<b>Docket Number:</b>	15-AFC-02
<b>Project Title:</b>	Mission Rock Energy Center
<b>TN #:</b>	215570
<b>Document Title:</b>	Mission Rock Energy Center (15-AFC-02) Updated Air Quality and Public Health Sections
<b>Description:</b>	The CD containing the air quality and public health modeling input and output files are with the Project Manager, Mike Monasmith
<b>Filer:</b>	Deric Wittenborn
<b>Organization:</b>	Ellison Schneider Harris & Donlan LLP
<b>Submitter Role:</b>	Applicant
<b>Submission Date:</b>	1/23/2017 5:29:13 PM
<b>Docketed Date:</b>	1/24/2017

Subject: Mission Rock Energy Center (15-AFC-02)  
Updated Air Quality and Public Health Sections

APPLICATION FOR CERTIFICATION  
MISSION ROCK ENERGY CENTER (15-AFC-02)

Section 5.1, Air Quality (CLEAN)

Figure 5.1B-1 (Revised)  
Mission Rock Site and BPIP Structures

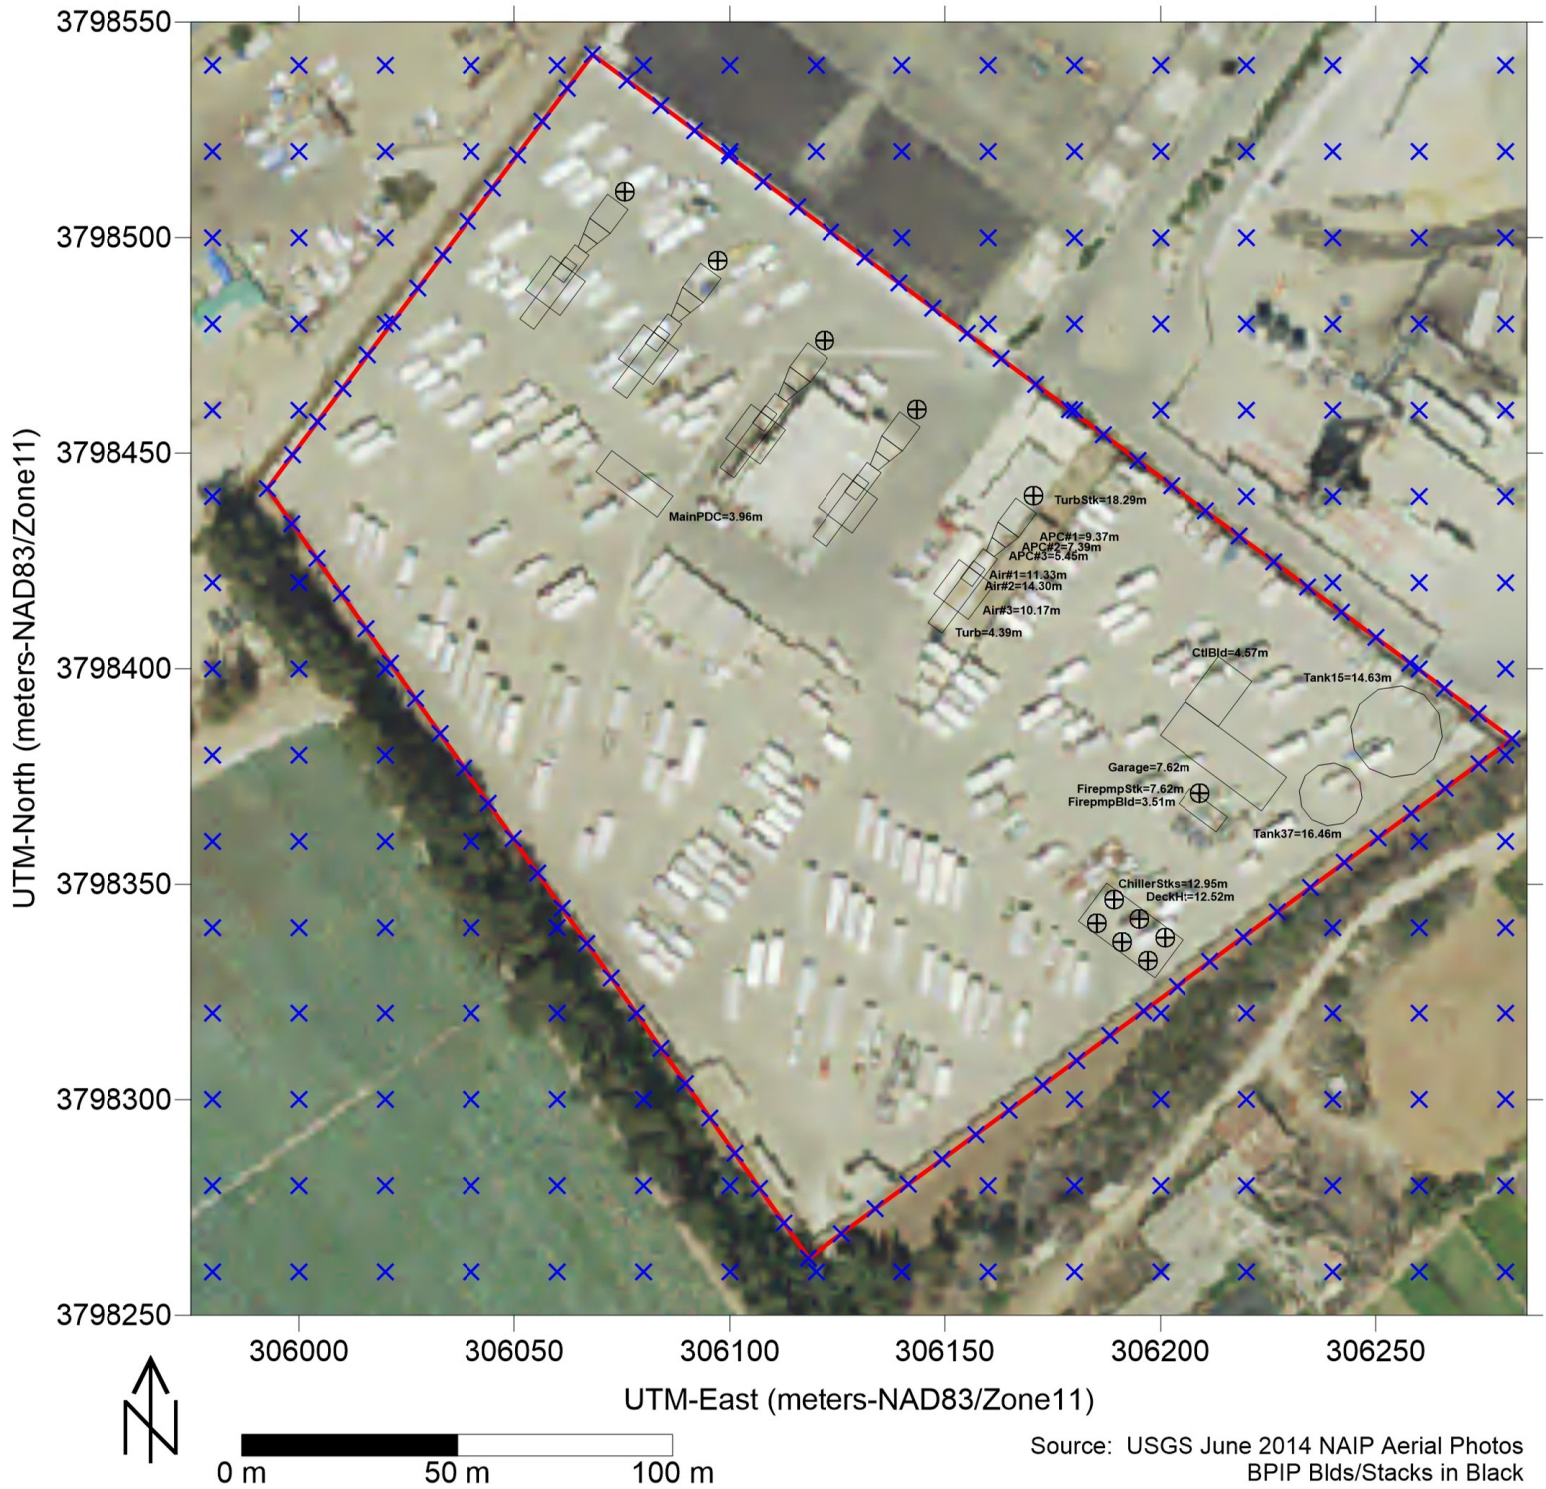
- Updated meteorological data set, provided by the San Joaquin Valley Air Pollution Control District;
- Revised SO<sub>2</sub> emission rates, based on the recommended use of 0.75 grains/standard cubic foot by the Ventura County Air Pollution Control District;
- Use of the EPA approved CTSCREEN dispersion model for complex terrain impacts;
- Revised Health Risk Assessment based on the updated meteorological data set; and
- Revised construction impact modeling assessment using the updated meteorological data set.
